BAGHDAD MUNICIPAL
SOLID WASTE LANDFILL

SIGIR PA-06-067
OCTOBER 19, 2006

SUBJECT: Report on Project Assessment of the Baghdad Municipal Solid Waste Landfill,
Baghdad, Iraq (Report Number SIGIR-PA-06-067)

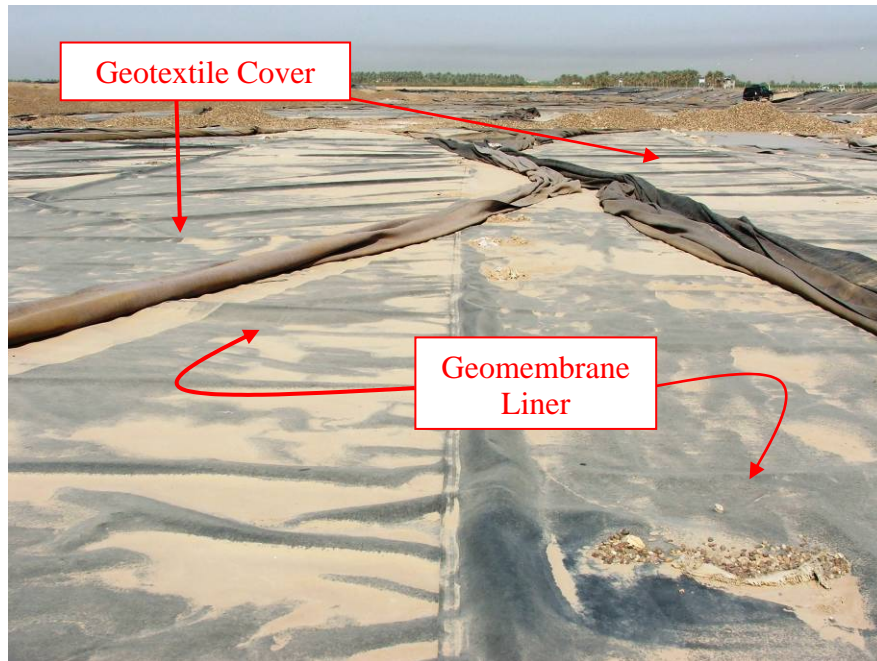
The MSW landfill construction included the first cell (Figure 1), with an area of approximately 9.7 hectares, located on the eastern part of the site. The MSW landfill site components visible for inspection included the geomembrane liner system, a drainage layer, a perimeter berm, and a leachate collection system.

Figure 3. Cross section of the berm slope

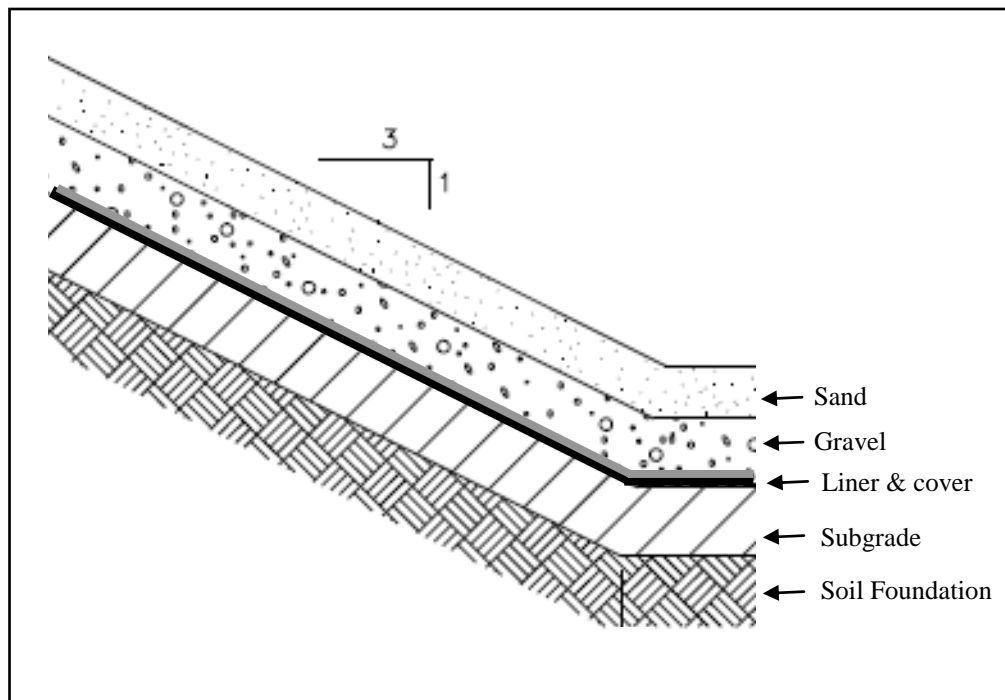
We observed the berm in place along the perimeter of the MSW landfill. The design required the liner system to extend up the 3 horizontal to 1 vertical side slope of the berm and terminate in an anchor trench along the top of the perimeter berm. In the unfinished areas of the landfill, the liner along the inside of the berm, as shown in Site Photo 6, will require remedial work to ensure it is placed and anchored properly.

Site Photo 11. Landfill site electrical generator

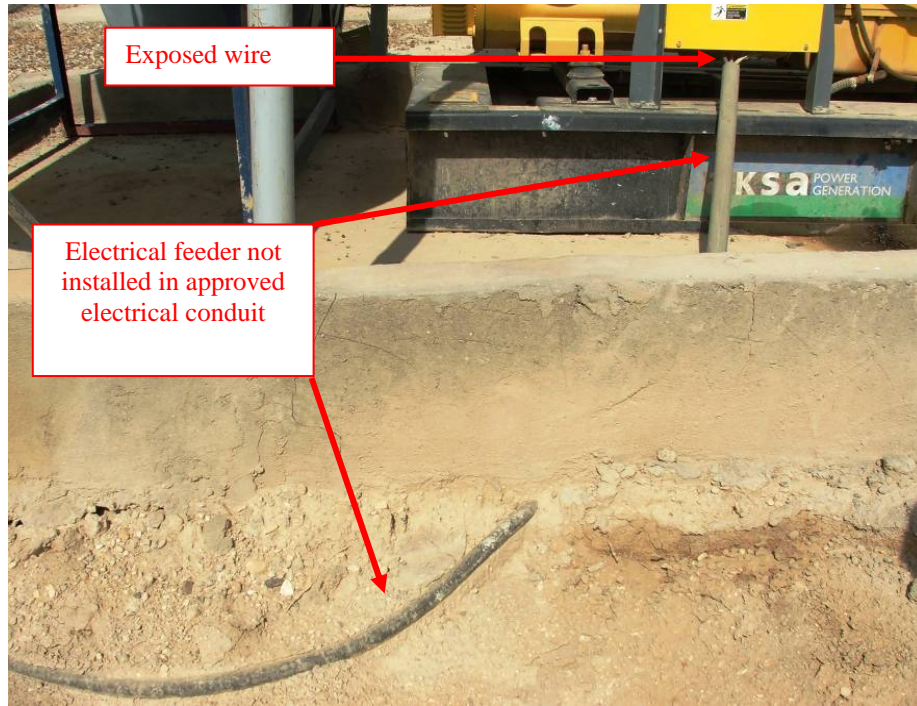
The generator on site is shown in Site Photo 11. The factory plate attached to the generator shows an Italian made “Mecc Alte Spa ECO 37-1L/4250 KVA” generator. However, the generator skid indicates an “AKSA” model generator. AKSA generators are manufactured in Turkey. Further, the factory plate (Site Photo 12) has yellow paint on its surface indicating the generator was painted after the factory plate was attached.

In addition, we observed several examples of questionable workmanship associated with the installation of the generator.

- The exhaust stack, shown in Site Photo 11, was not properly supported. Also, it appears vibration of the generator could damage the roof and/or generator because the stack location being so close to the metal frame and the roof skin.
- The feeder cable shown in Site Photo 13 was not properly installed in conduit. The connection to the generator control panel was made with exposed wire, not enclosed in conduit. Further, part of the feeder cable was lying exposed on the ground surface. The cable was not in conduit as required by the design nor buried to a proper depth.
- The generator skid was not anchored to the concrete pad.
